North Coast Regional Water Quality Control Board

Subject: **Notice of Violation** of the *Water Quality Control Plan for the North Coast Region* and Order No. R1-2004-0030, *General Waste Discharge Requirements for Discharges Related to Timber Harvest Activities on Non-Federal Lands in the North Coast Region*; and
13267 Investigative Order Pursuant to California Water Code section 13267, for Sierra Pacific Industries

File: THP 2-15-021 TRI "YESMON" (CW-814600)

Figure 1: Excerpt from page 55 of Section II of the approved THP

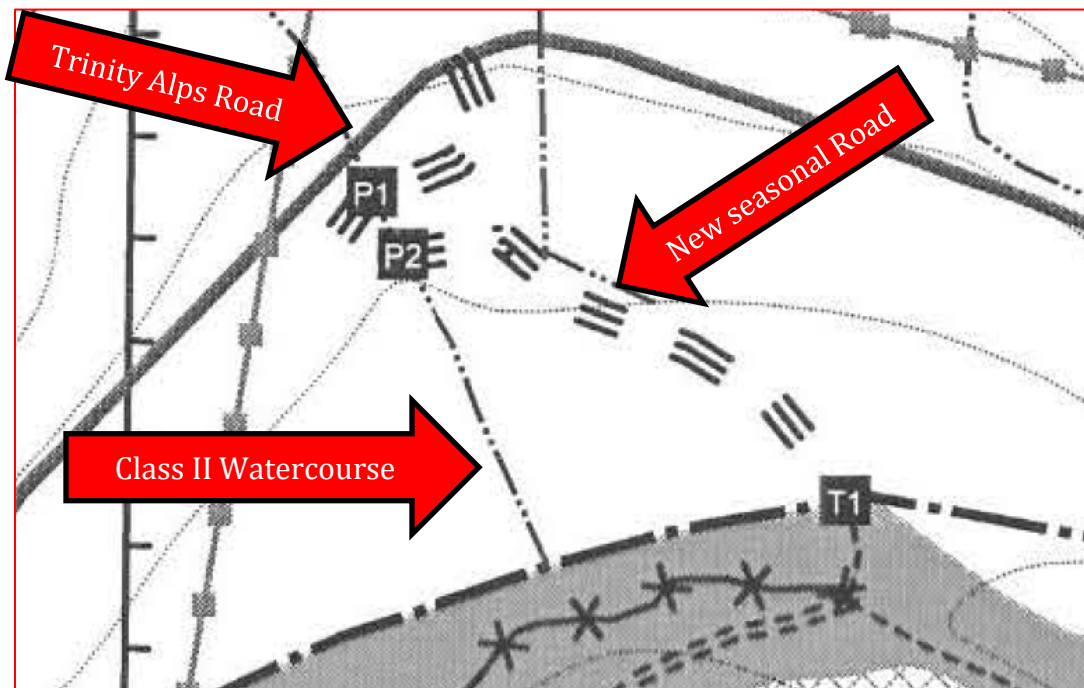
The approved THP includes construction of approximately 800 feet of new seasonal road to access THP Unit 3527 (Figure 1) including a switchback located over a Class II watercourse. Two new culverted watercourse crossings, P1 and P2, were proposed to be installed and connected to the existing 18-inch diameter corrugated metal pipe (CMP) that conveys flow from the Class II watercourse under Trinity Alps Road. Trinity Alps Road is a Trinity County road and is located immediately upstream of the new seasonal road construction. The outlet of P2 was proposed to convey stream flow onto the floodplain of Stuart Fork.

Figure 4: Annotated panorama of the seasonal road switchback

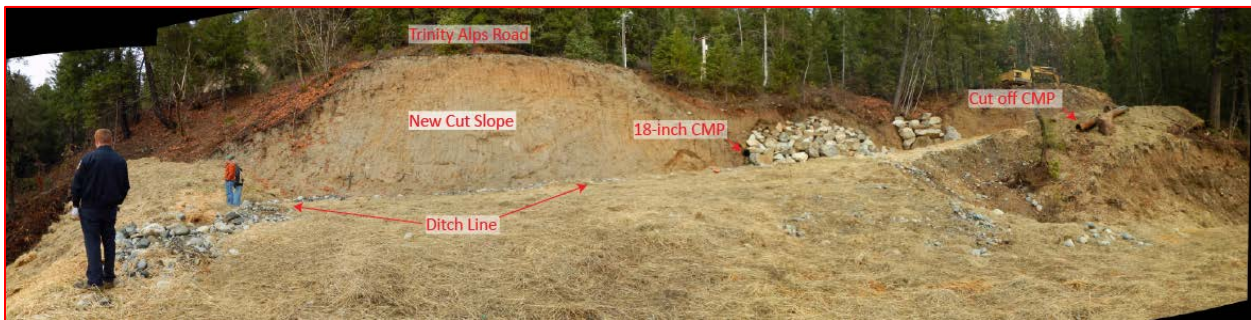
The PHI inspection team assessed the Class II watercourse and switchback on the new seasonal road construction where P1 and P2 were proposed to be installed (Figure 4). Exposed fill on the new seasonal road construction was stabilized with straw mulch, but the road was not rocked as proposed in the THP.

Figure 8: Excerpt from Page 55 of the approved THP.

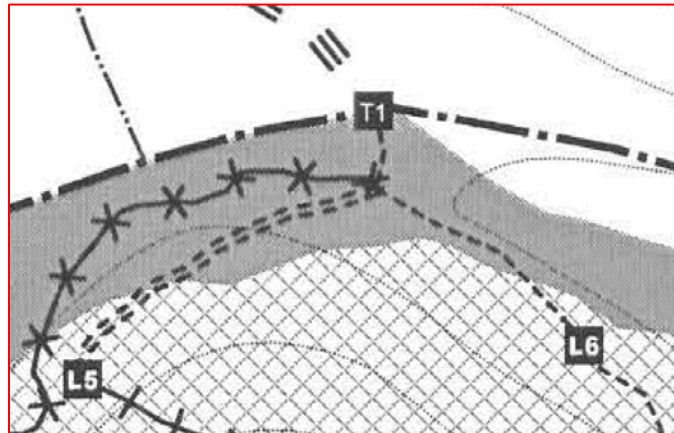
AM3 proposes change the approved running surface of the temporary roads within the Class I WLPZ of Stuart Fork (Figure 8) to straw mulch instead of rock, as originally proposed in the THP. We observed that temporary road construction and reconstruction proposed in AM3 had already occurred, and according to Mr. Walz, the majority of log hauling on these temporary roads had also already occurred. Only a few loads of logs remain on the landings, and the landowner proposes to haul those logs next year.

Figure 1: Map showing the spatial layout of the floodplain of Stuart Fork

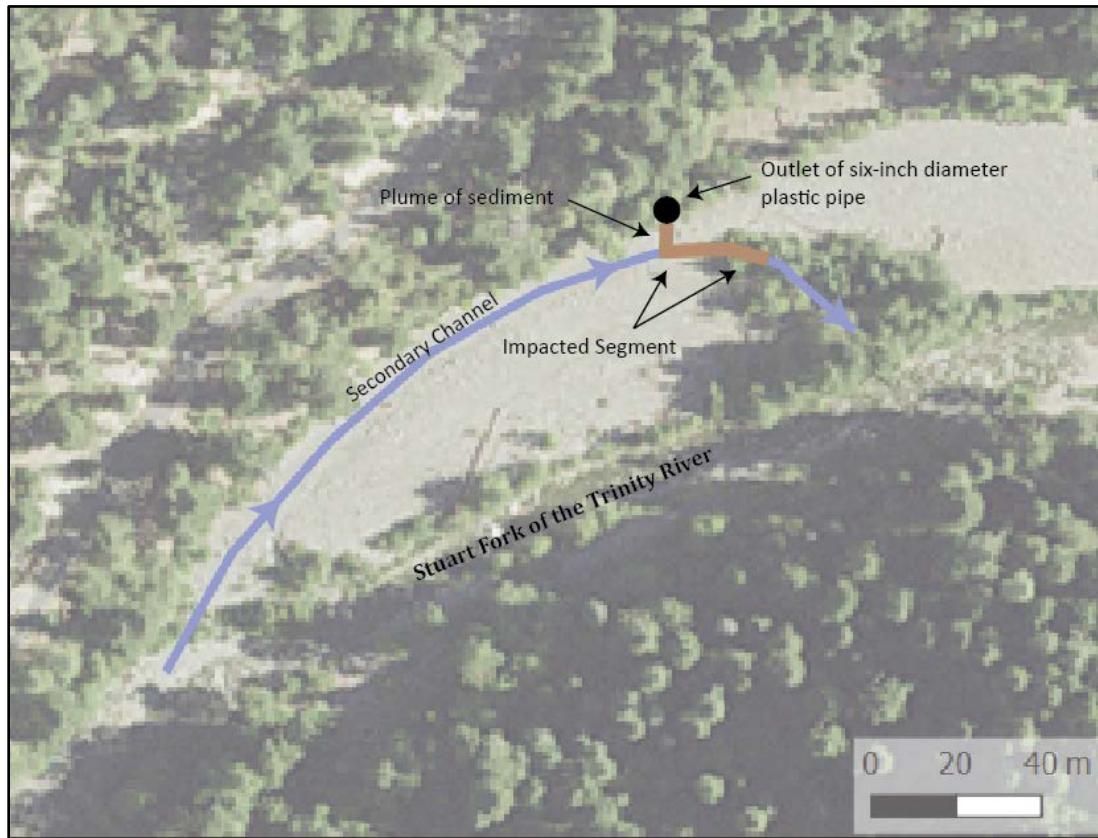
Tim and I then inspected impacts to the secondary channel and the floodplain of Stuart Fork. We observed that the secondary channel upstream of the plume contained only native material and was not impacted with material from the plastic flexible pipe. We measured a 110-foot long segment of continuous deposition in the channel downstream from the confluence of the plume and secondary channel. We measured the secondary channel beyond this point an additional 110-feet before meeting the primary channel. In this lower segment the channel banks become vegetated, the channel widens to 42 feet, and deposition becomes intermittent as the flow begins to slow and move subsurface (see Figure 1).

In the upper portion of the secondary channel we observed ripple marks in sediment deposited on the floodplain and above the water line (see Photo 8). In the lower portion of the secondary channel we observed thin intermittent deposits of fine sediment on the cobbles (see Photo 9). Based on our observations it appeared that recent high flows had delivered sediment from the secondary channel into the primary channel of Stuart Fork.
